January 22, 2024  
 Ref.: 308102

**Re: Public Tender No. PD23001945 (the “Tender”) – Clarifications #3**

### Pump J4 Results

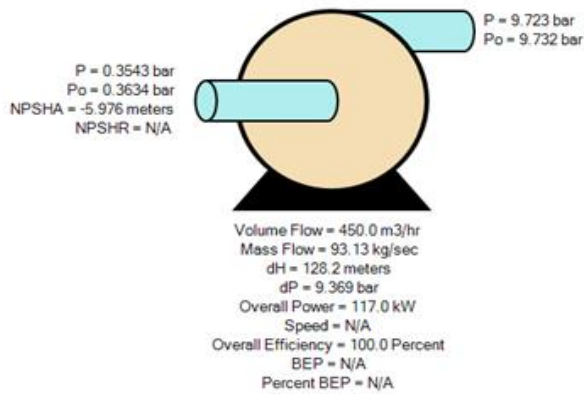
<u>Question</u>	<u>Answer</u>
1.	Technical	<p>Doubt of the NPSHav. of the Distillate transfer pump which is confirmed to be -6m when sump depth is 1.65 and the NPSH req. of our possible pump selection is something more than 4m.</p> <p>To be able to make proper selections for both pump services, please request for both sump drawings. Based on PEI’s reply we understand that the pumps will be installed in these existing casings, so we need to have existing dimensions</p>	<p>In regards to the NPSHa – it is important to note that the pump should be <b>self-priming</b>. In regards to the relative level, see attached sketch. We wish to have NPSHA of -6m at the suction valve of the pump. If the manufacturer can have a lower NPSHA (e.g. minus 8 meters – it is preferred since we can then have more flow)</p> <p>We have modeled:</p>
